GROUP ELE	MODEL 2011-2014MY Sedona (VQ) w/PSD
	NUMBER 232	DATE March 2020
<b>TECHNICAL SERVICE BULLETIN</b>		
<b>SUBJECT: POWER SLIDING DOOR (PSD) OPERATION INSPECTION AND REPAIR</b>

## POWER SLIDING DOOR (PSD) OPERATION INSPECTION AND REPAIR

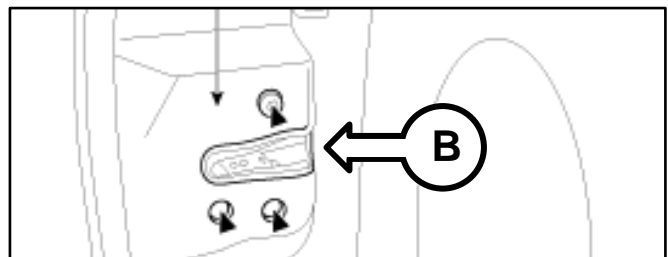
- 1a. The PSD (Left or Right Side) will not closed fully and/or is secured on the 2nd stage latching after closing in auto-mode.
- 1b. **Repeat closing of the PSD in auto-mode after four warning alerts.**
- 2a. **Do not replace the PSD drive unit/motor (A),** instead it is recommended that if the **PSD does NOT close normally,** proceed to diagnose by referring to the shop manual on KGIS to replace the Rear Door Latch Assembly or Rear Door Actuator.

- 2b. Replace the Rear Door Latch Assembly (B) or Rear Door Actuator (C) as needed.

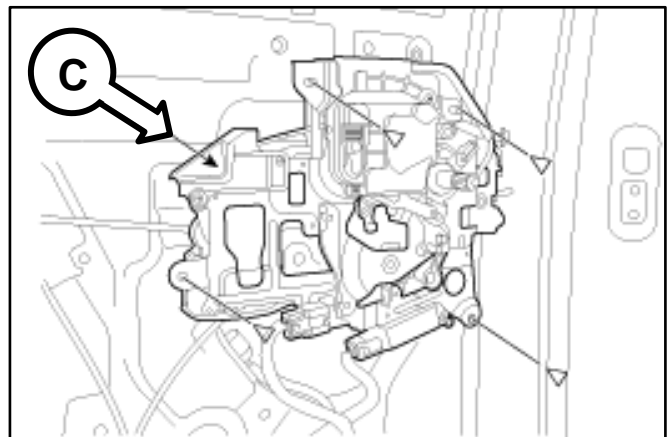
Replace the PSD rear door latch assembly (B) by referring to the “Body (Interior Exterior) → Exterior → Rear Door → Repair procedures” chapter in the applicable Shop Manual on KGIS.
